ADDENDUM 4
City of Newport News
IFB#2011-3736-2005

STONEY RUN COMMUNITY CENTER PHASE II

This published addendum consists of questions, answers, changes to specifications and drawings.

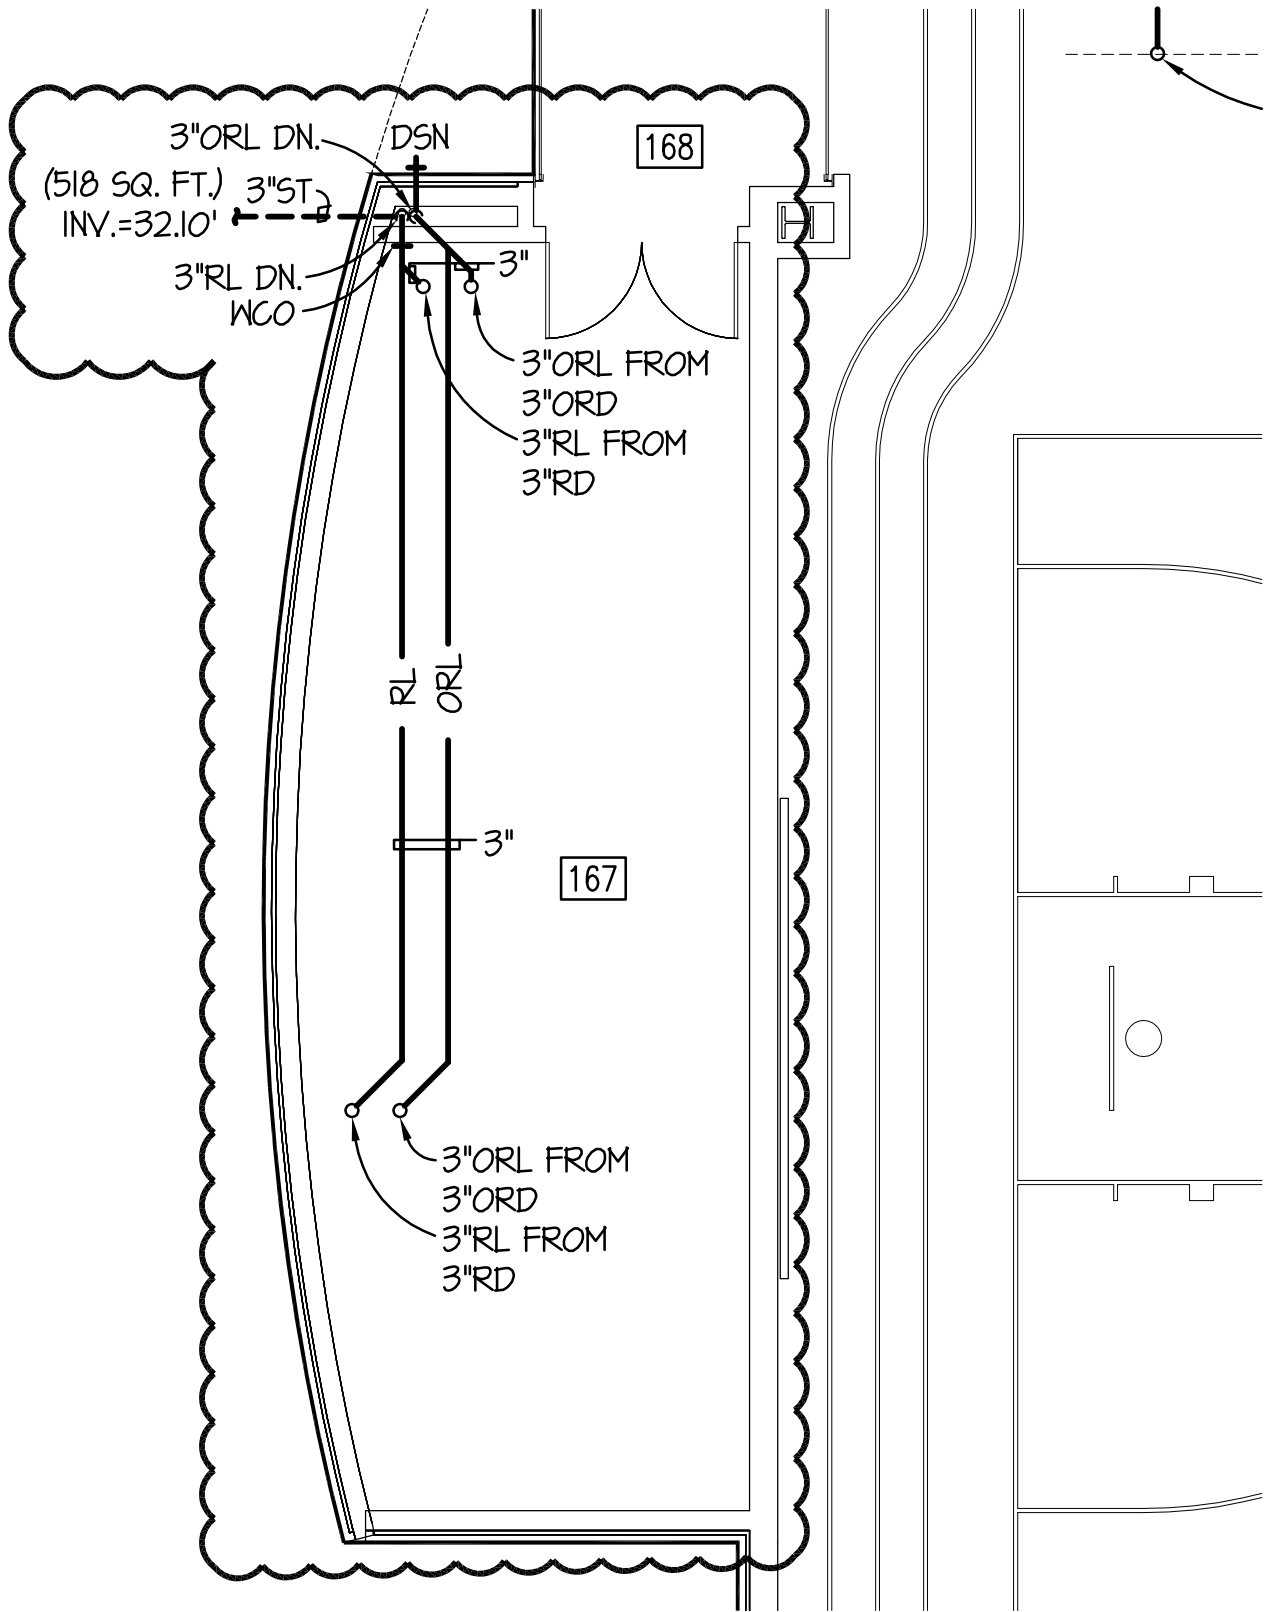
ITEM NO. 19 SHEET C4.0, UTILITY PLAN

ADD: Connection for storage room roof drainage, as shown in Sketch SK-C1, included with this Addendum.

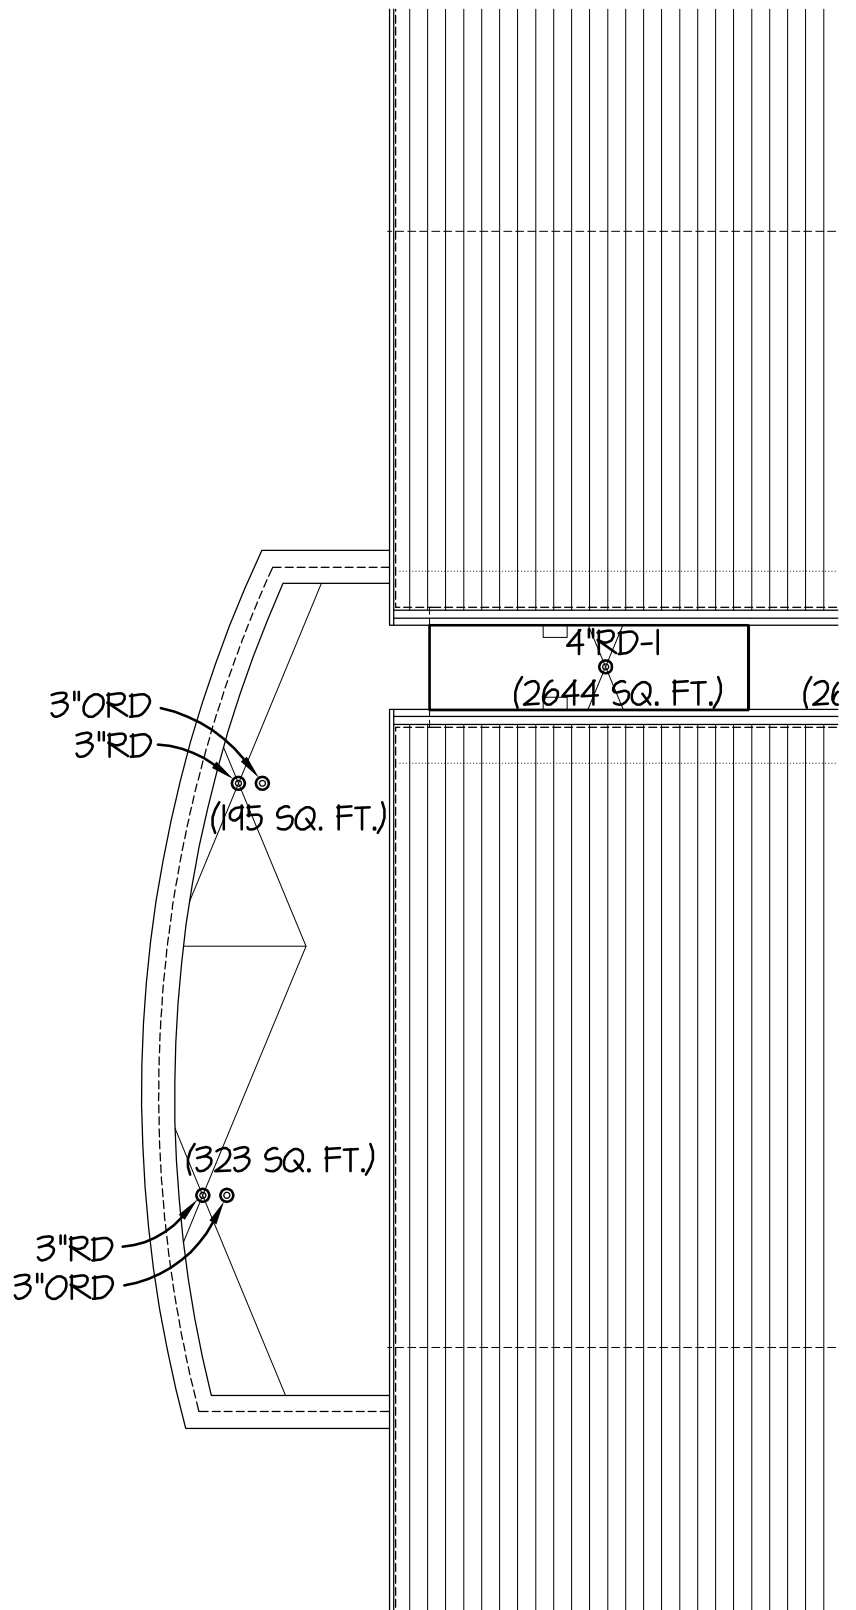
- Question 30: The Plumbing plans do not address the roof and overflow drains shown on A-301 Roof Plan at Storage Room 167 roof.
- Answer 30: Sketches are given by addendum to address these roof drains.

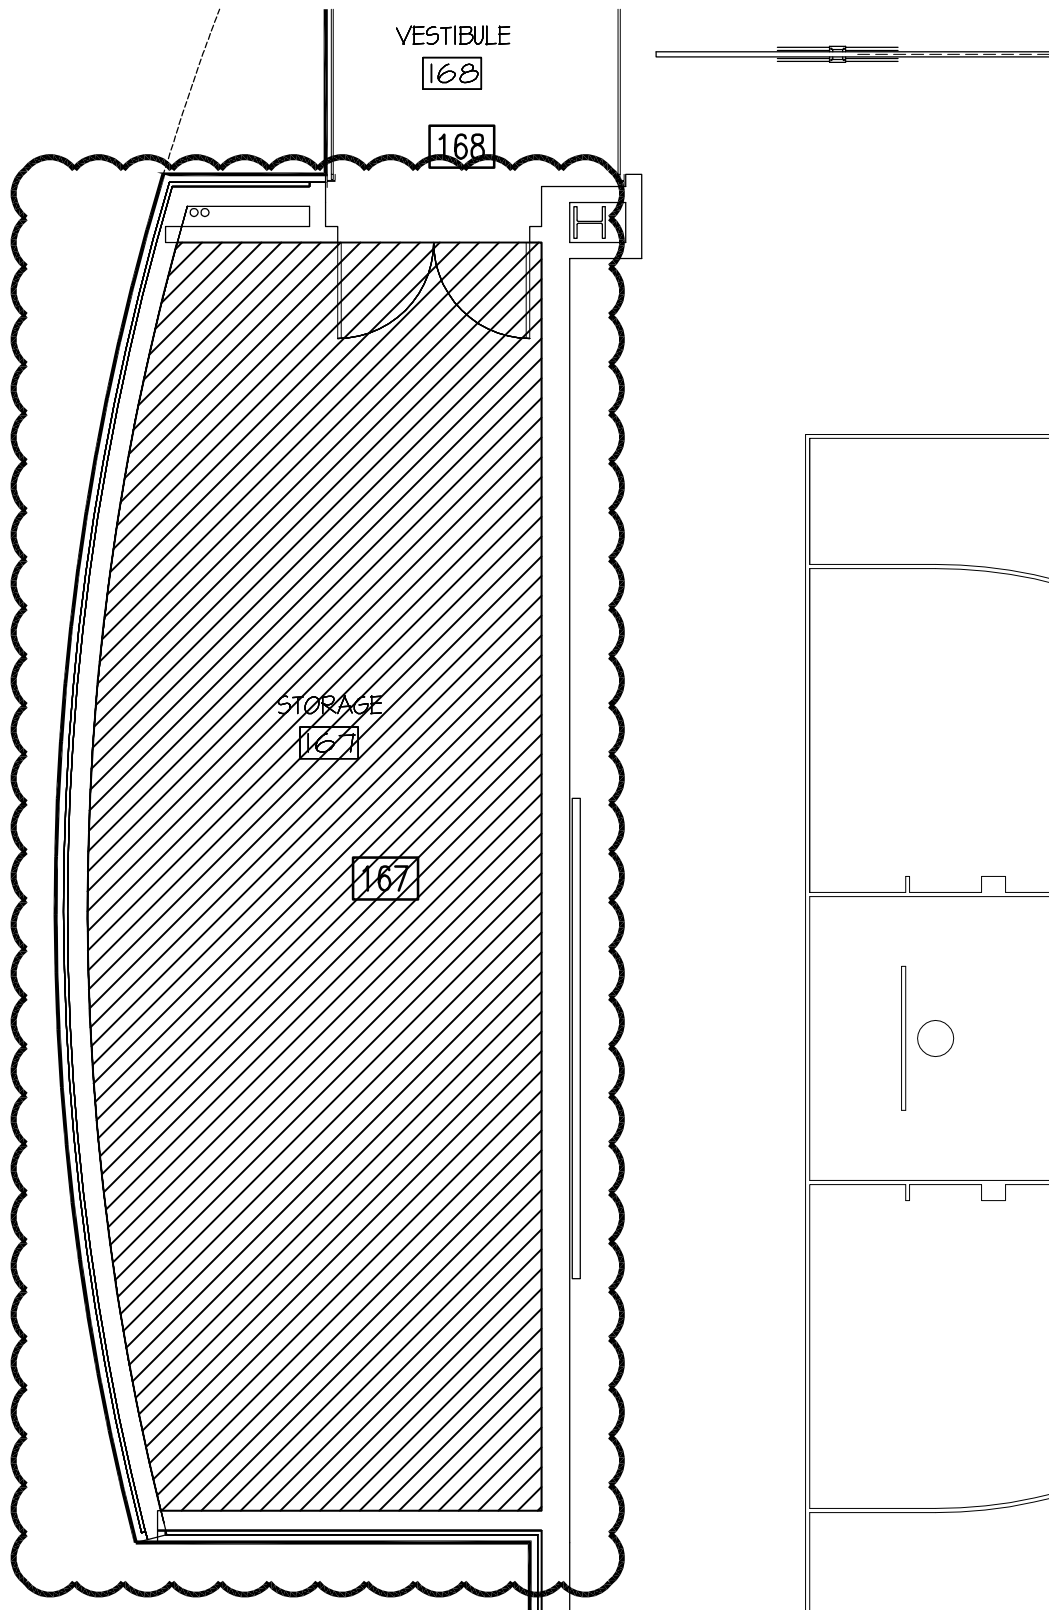
ITEM NO. 22 SHEET SHEET SP1.02, PARTIAL FLOOR PLAN – AREA B - SPRINKLER

ADD: Normal hazard occupancy designation for Storage Room 167, as indicated in Sketch Sk-SP1, incl
